UNITED STATES PATENT AND TRADEMARK OFFICE

10/566,816

Office Action Summary	Application No. 10/566,816	Applicant(s) HUBERT, JEAN-CLAUDE	
	Examiner KAREEN RUSH	Art Unit 4128

DETAILED ACTION

FIG. 6

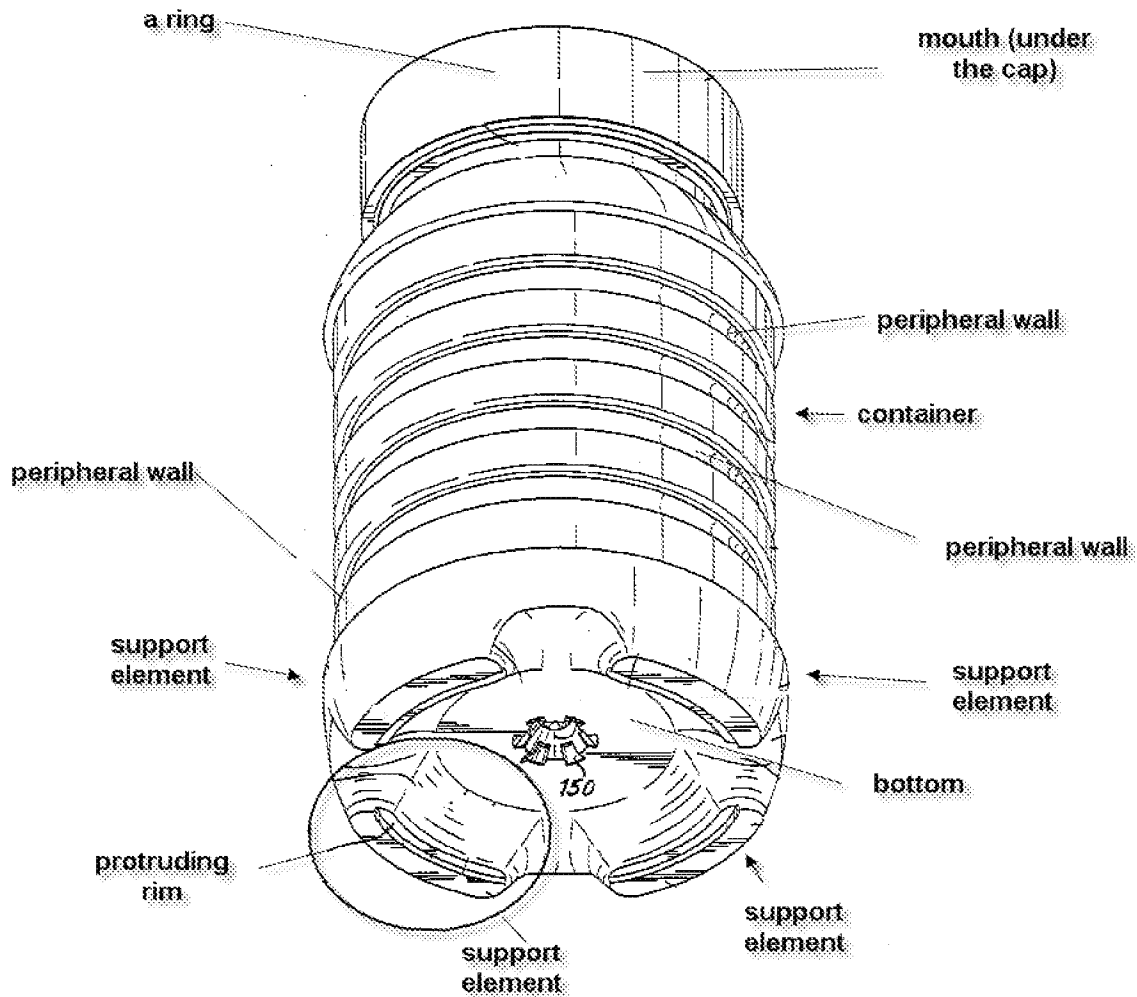
a. Regarding claim 1, Tobias teaches a container (in annotated Fig. 6) for containing foodstuff. The container comprises a bottom (in annotated Fig. 6); a peripheral wall (in annotated Fig. 6), integral with the bottom and extends upward from the bottom and defines a mouth opening (in annotated Fig. 6). There is at least one support element (in annotated Fig. 6) arranged on the bottom at a position corresponding to the edge of the mouth opening, such that in a stacked position of at least two identical containers, the support element of the first container rests on the edge of the mouth opening of the second container (it is inherent that the lid rests on the edge of the mouth opening and the second container rests on the lid and the edge of the mouth opening in Tobias Fig. 5 at 56) and at least three support elements (in the above annotated Fig. 6) in the form of a bulge are formed in the bottom and side wall and protrude beyond the bottom plane. The Tobias reference DIFFERS in that it does not teach a foil layer in between the mouth and the lid that is on the edge of the mouth of the container. Attention however is directed to Fuller which discloses another stackable container. The stackable container has a foil seal (Fuller, Fig. 1 at 20) over the container's mouth and the cap or lid resting on the containers opening over the foil seal. Therefore, it would have been obvious to one of ordinary skill

b. Regarding claim 2, Tobias teaches the bulges protrude beyond the peripheral wall (in the above annotated Fig. 6).

c. Regarding claim 4, Tobias teaches the at least three support elements (in the above annotated Fig. 6) are evenly distributed over the bottom.

d. Regarding claim 5, Tobias teaches the support element comprises a protruding rim or support ridge (in the above annotated Fig. 6).

FIG. 9

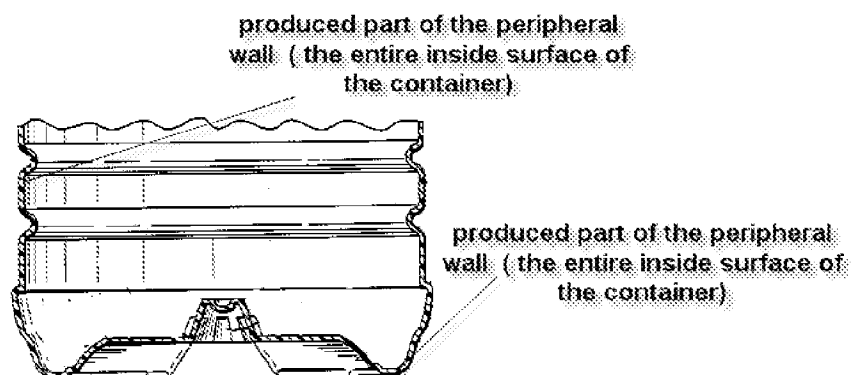
e. Regarding claim 6, Tobias teaches the support element is arranged inside the produced part of the peripheral wall (in the above annotated Fig 9).

f. Regarding claim 7, Tobias teaches the bottom and the peripheral wall integral with the bottom are connected via a rounded off corner portion or bumper (Tobias, Fig. 9 at 122).
